**Official Transcript of Proceedings**  
**NUCLEAR REGULATORY COMMISSION**

Title:                   Advisory Committee on Reactor Safeguards  
                              Hope Creek License Renewal Subcommittee

Date:                    Wednesday, November 3, 2010

7 HOPE CREEK LICENSE RENEWAL SUBCOMMITTEE

# Drywell / Reactor Cavity Seal Area

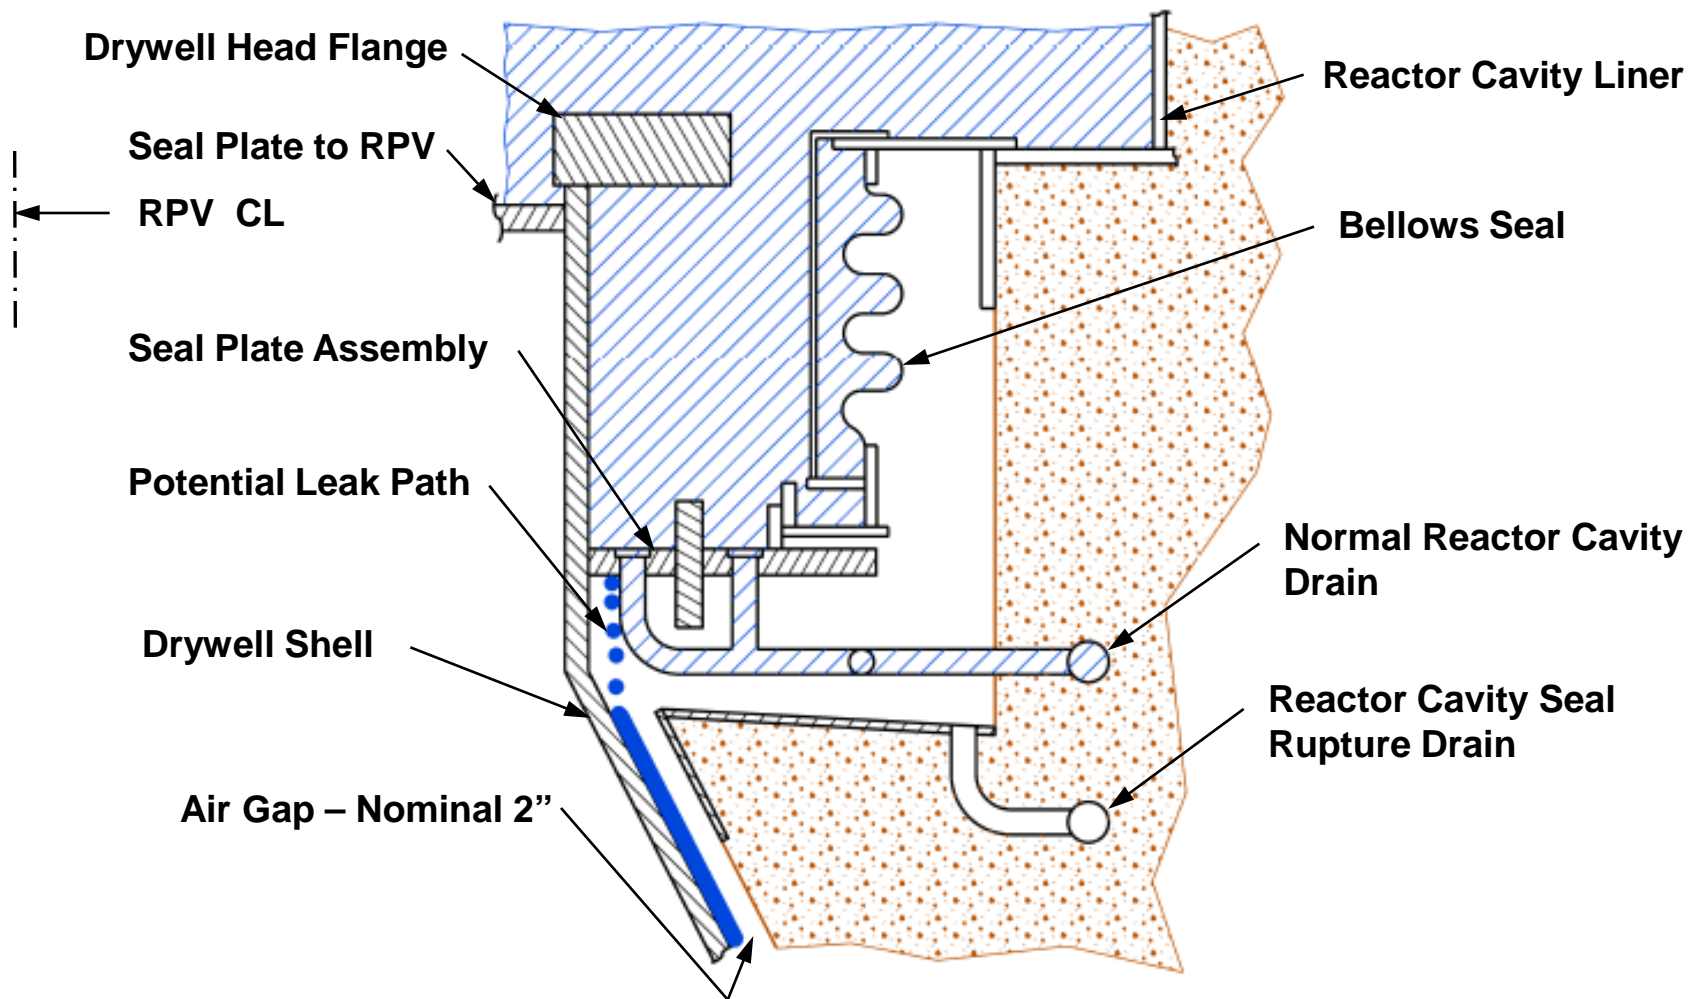
17 MEMBER STETKAR: Greg, I will ask the  
18 stupid question I have to ask. You're confident that  
19 your reactor cavity seal rupture drainlines are open?

20 MEMBER STETKAR: Greg, before you go on, I  
21 will ask the same stupid question about the air gap  
22 drains. Are there positive ways of determining that,  
23 indeed, those air gap drainlines are not blocked?

9 That system is a completely welded system  
10 designed to handle radwaste. Currently, we are  
11 providing a design change to provide a port to assure  
12 us that that drainage is open. The instrumentation  
13 for that drainline is checked every 18 months  
14 electrically. So, once we provide a port in there, we  
15 can assure ourselves no blockage of that line.

# Lower Drywell Area

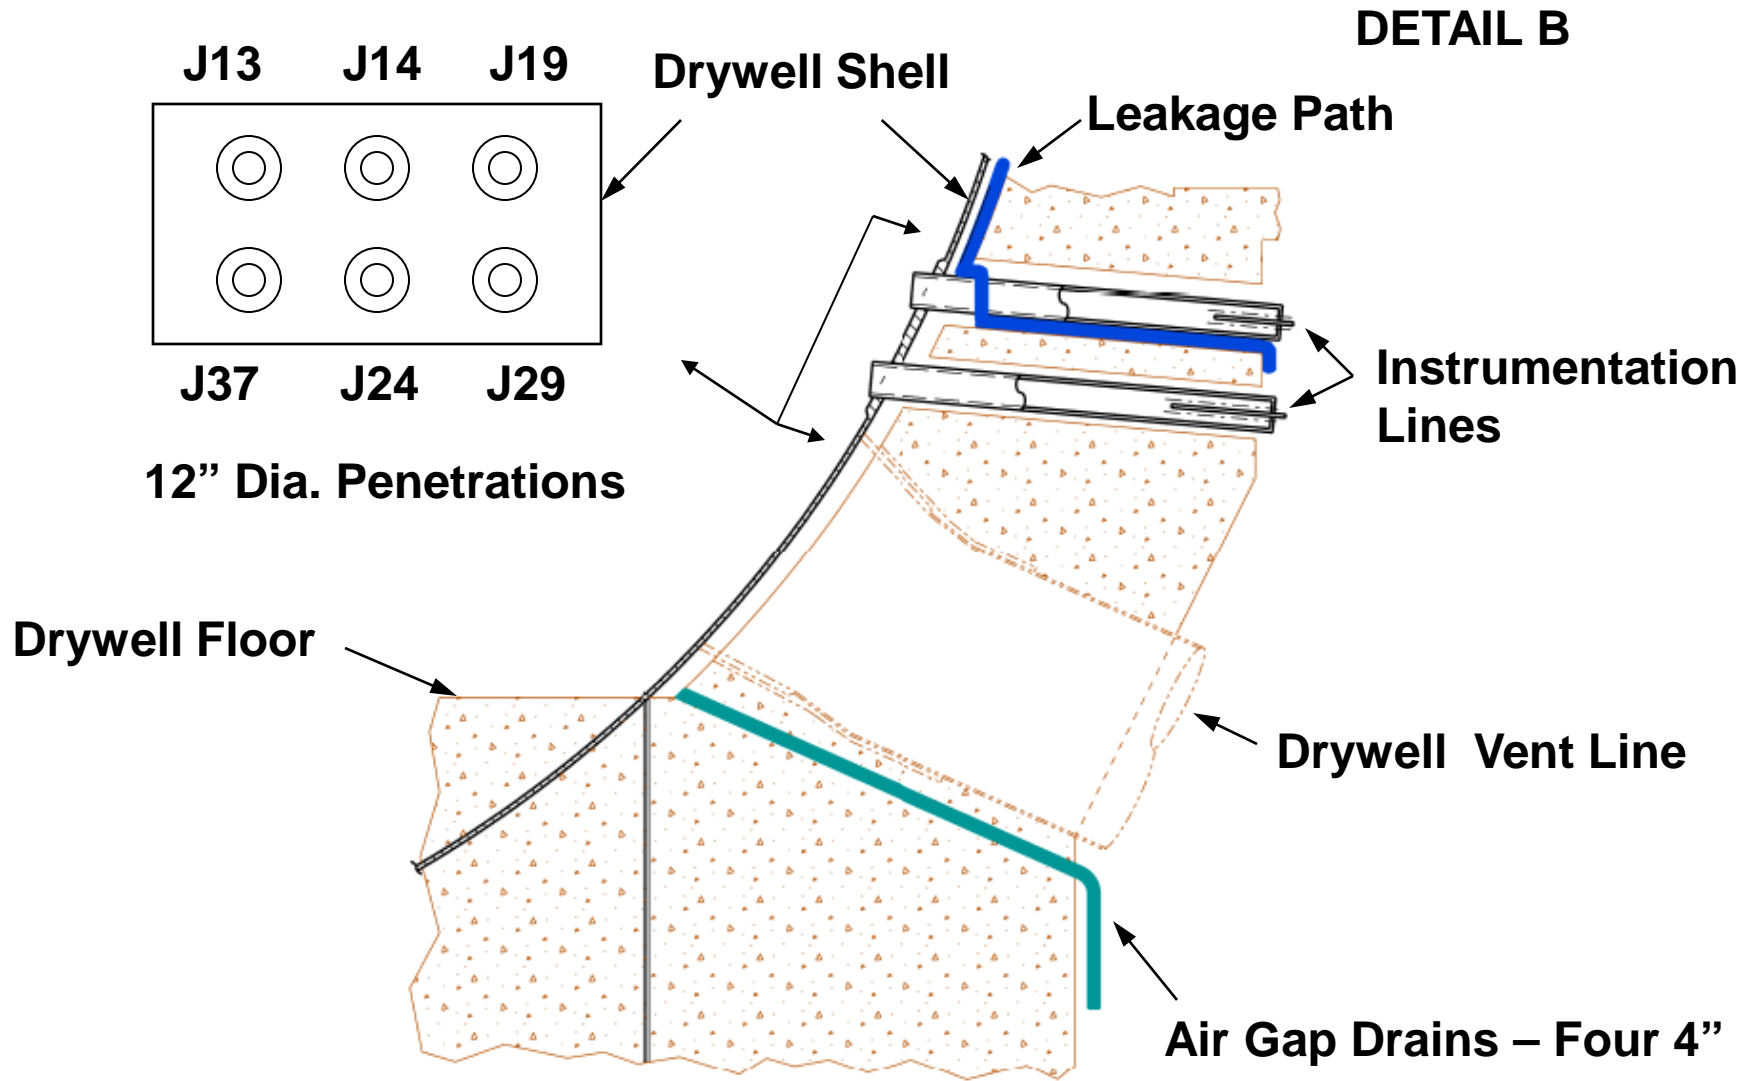
16 MEMBER SIEBER: Now that drawing sort of  
17 shows that, if you wanted to, right at the drywell  
18 floor on the inside, you could perhaps do a UT, but --
